Generic Design Assessment – New Civil Reactor Build
Step 4 Mechanical Engineering Assessment of the Westinghouse AP1000[®] Reactor

Assessment Report: ONR-GDA-AR-11-010
Revision 0
11 November 2011

Figure 1
CRDM - Latch Assembly Arrangement

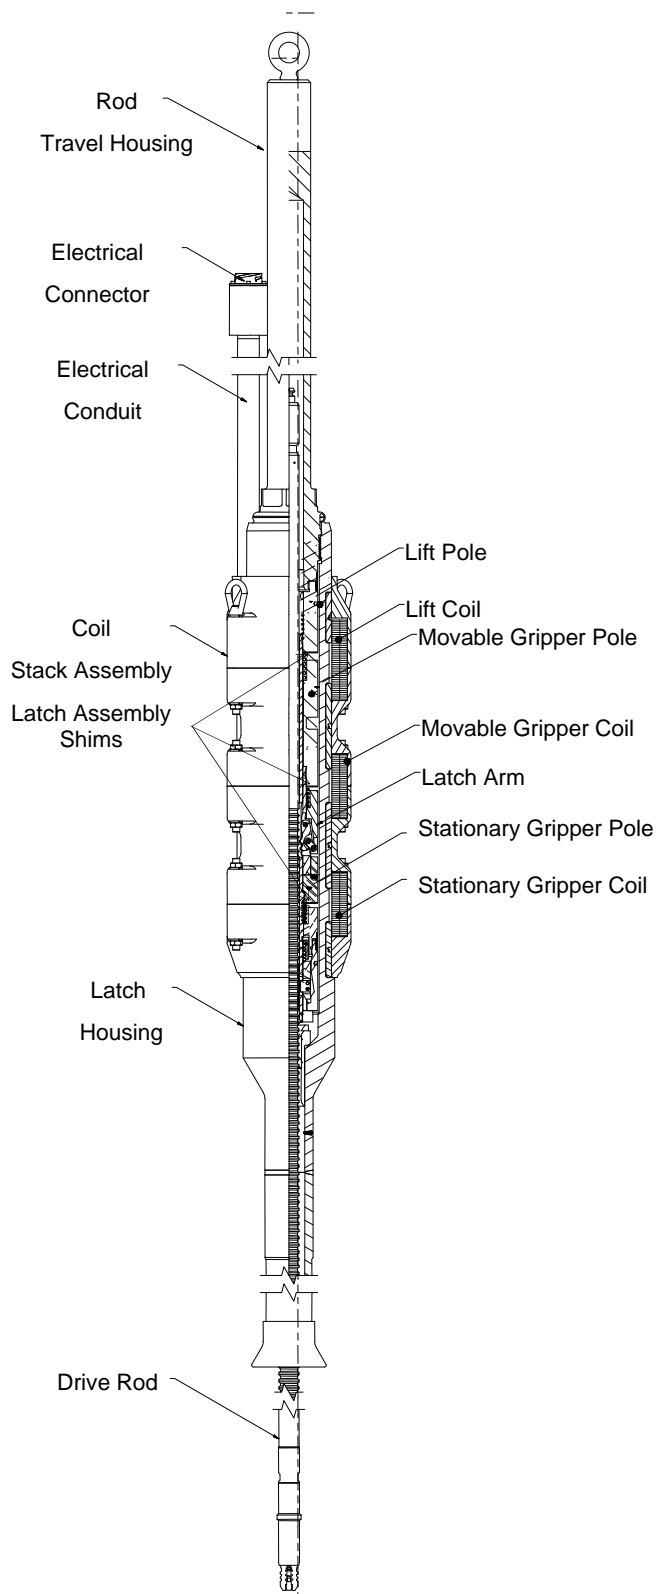
148 The latch mechanism (Figure 1) contains stainless steel shims, which are located between the magnets with their purpose to provide an insulation barrier between the different magnetic fields. The life time test found that a number of shims contained cracks and one shim was found to have split into two. However, Westinghouse claimed that the assembled tolerances of the latch assembly retain the shims in situ.

149 Westinghouse subjected the CRDMs to just over eight million steps, and has made a six million cycle claim on the CRDMs in terms of design life. I consider in principle this represents an acceptable margin. However, based on the above evidence associated with the shim performance, and the fact that the replacement shims were only subjected to the order of two million steps, my regulatory judgment is that there was a significant shortfall in the evidence for a six million step claim.

- 151 Westinghouse has confirmed that the selected shim material is [REDACTED], they have no plans to carry out any additional life time tests for the CRDMs, and the [REDACTED] shims at the time of carrying out the Life Time Test had not been subjected to any detailed metallurgical analysis (in terms of material testing or microstructure examination).

- 155 In response to my line of enquiry Westinghouse made the following claims, which I have commented on as part of my assessment activity:
- Shim cracking in no way hinders the functionality of the latch assembly. I judged this to be unsubstantiated at the time. My judgement was based on consideration of the small sample size of 4 units tested, and the fact the design criteria of being functional for 6 million steps was outside previously well understood and substantiated design parameters for a CRDM.

- A potential cause for the circumferential cracking is the impact loads of the stepping sequence being in excess of the 304 Stainless steel yield strength. The [REDACTED] [REDACTED] has a higher yield strength and subsequently does not yield under stepping action. At the time I considered Westinghouse needed to increase their understanding in this area, and provide evidence of why the 304 stainless steel material suffered circumferential cracking, and that this fault would not occur for the replacement [REDACTED].

ADS Stages 1, 2 & 3 – Schematic Flow Diagram

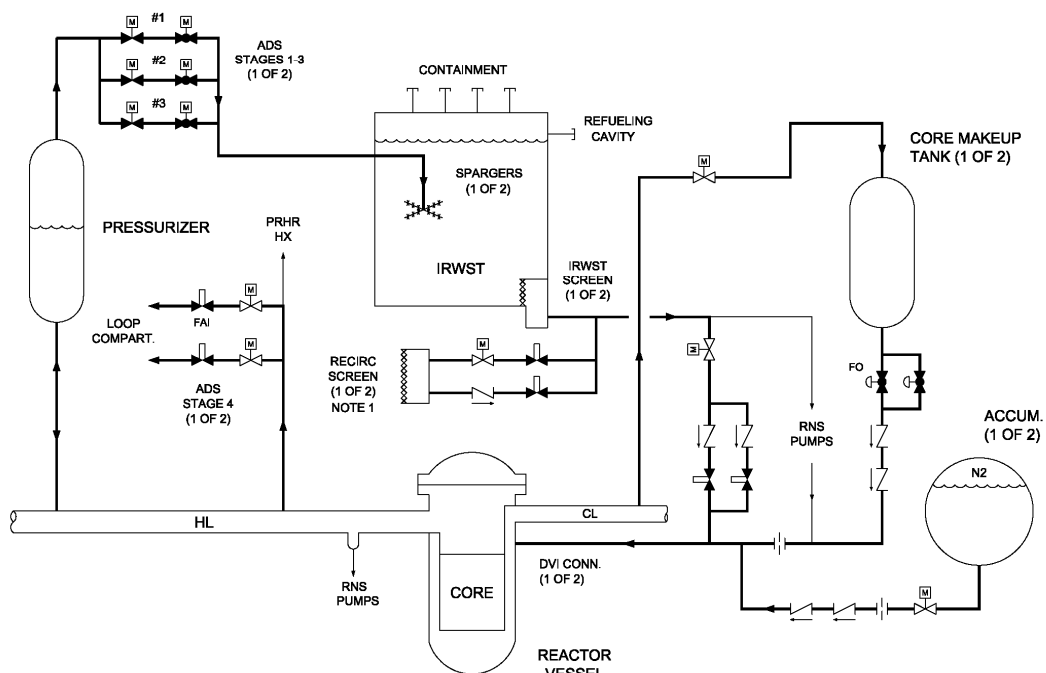
182 Westinghouse has provided information that explains that the ADS (Figure 2) acts in conjunction with the Passive Core Cooling System, whose purpose is to mitigate the consequences of a Loss of Coolant Accident. The system configuration consists of two

process trains, with each train branching off into 3 parallel lines, with each line containing 2 isolation valves in series. The first valve is a gate valve, which acts as reactor coolant pressure boundary isolation. The second is a globe valve which provides a second backup isolation role. A further process line containing a solenoid valve is provided. This line enables the gate valves to be tested during outages. It was noted that this valve also forms part of the reactor coolant pressure boundary, and so acts as a primary circuit isolation valve. The ADS also uses squib valves, which are discussed in more detail in Section 4.10 of this report.

Passive Safety Injection - Schematic Flow Diagram

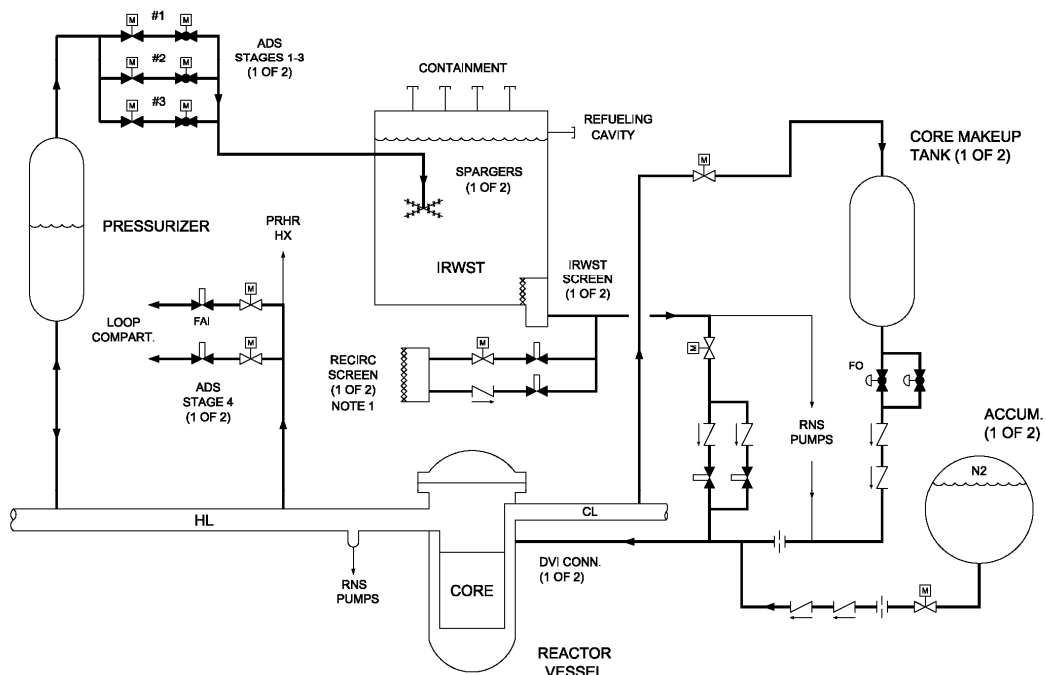
- 219 Westinghouse described the valve set up within the process line (Figure 3), and the justification for having the valve normally open on 'no flow and forward flow' and closing on 'reverse flow'. The type of valve in question is located downstream of each Core Make-up Tank and supports the Passive Core Cooling System. Each CMT process line contains two in-line check valves that are positioned in series. Located upstream are two globe valves that are positioned in parallel. During normal operations the upstream valves provide the passive core cooling isolation as they are normally closed. The inline check valves have no duty during this aspect of the process but are in the open position. On actuation of the ADS stages 1, 2 and 3 and the parallel isolation valves the Core Make-up Tanks passively inject boronated coolant into the reactor coolant system via the 2 open in-line check valves. The Probabilistic Risk Analysis (PRA) drives for the valves to be of a design that is set open with no flow so there is no consideration of an active failure to open on demand. On lowering the coolant level within the Core Makeup Tanks and the associated system pressure, the accumulators actuate under Nitrogen pressure to inject further boronated coolant into the reactor coolant system. During this injection process the two in-line check valves are required to close and isolate the line to the Core Makeup Tanks. Two in-line valves are incorporated to address the single failure criteria (i.e. one

valve suffering an active failure of 'failing to close'). I noted that the valves do not give consideration to passive single criteria failure whilst in their open position, and have identified this feature to my Fault Studies assessment colleagues. I understand this has been progressed via their RO in this area, Diversity of Frequent Faults and Consideration of Passive Failures, RO-AP1000-047 (Ref. 11).

AP1000 Automatic Depressurisation System - Schematic Flow Diagram

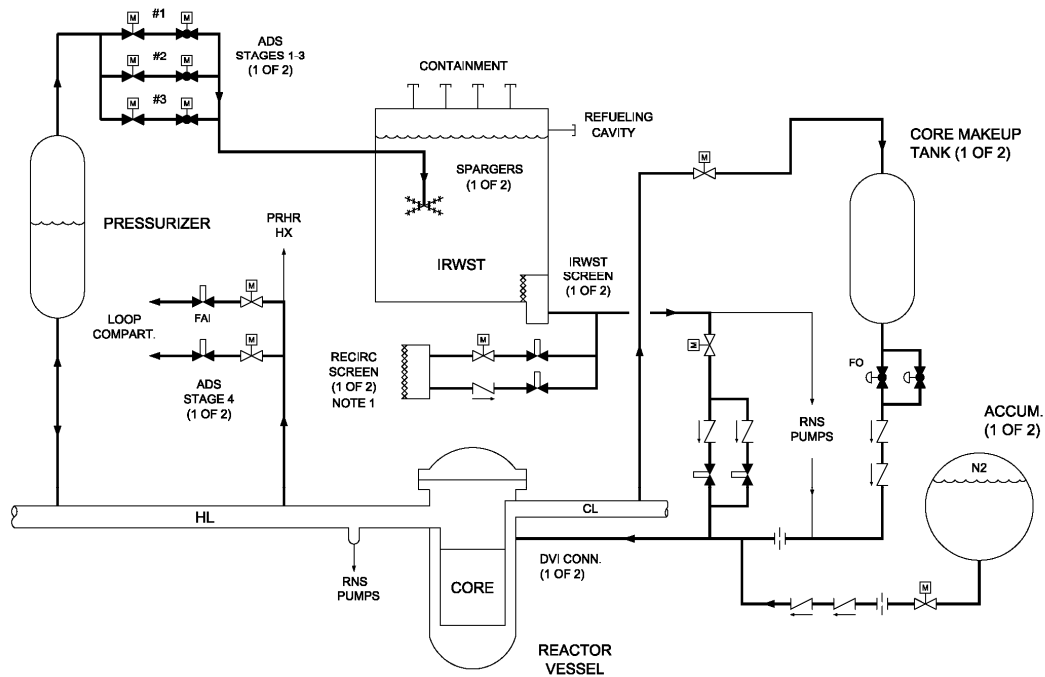
261 The AP1000 Automatic Depressurisation System (ADS) design (Figure 4) consists of 4 Stages. The first 3 Stages consist of 2 trains, all fitted with motor operated valves. Stage 1 is 4 inch nominal size, Stages 2 and 3 are 8 inch. Stage 4 consists of 4 individual 14 inch squib valves, 2 attached to each of the hot legs on the Reactor Coolant System pipework. I consider the ADS system contains a level of component diversity by the system design incorporating various different valve types.

- 490 I consider (from earlier discussion concerning the EMIT and surveillance requirements for the squib valves) there are now an increased number of occasions when each squib valve is required to be removed from its associated system pipework. I also consider the second argument not be consistent as each 4th stage ADS squib valve is isolated via a motor operated valve within a branch off the primary reactor coolant pipework (Figure 4).

Passive Residual Heat Exchanger – Schematic Flow Diagram

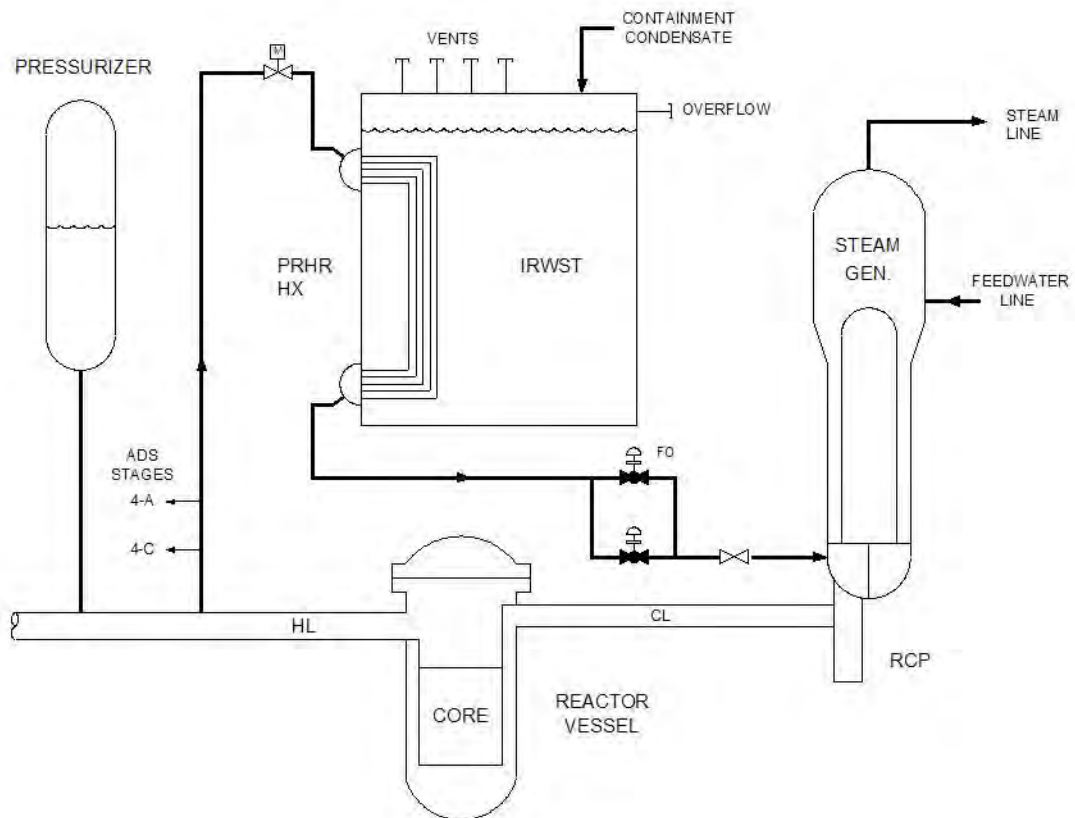
705 The PRHR HX is associated with the passive core cooling system of the AP1000. The PRHR HX is normally isolated from the appropriate Steam Generator RCS leg by two parallel, normally closed, fail open Air Operated Valves (AOVs). The PRHR HX can also be isolated by use of a single motor operated valve which is normally open (see Figure 5).
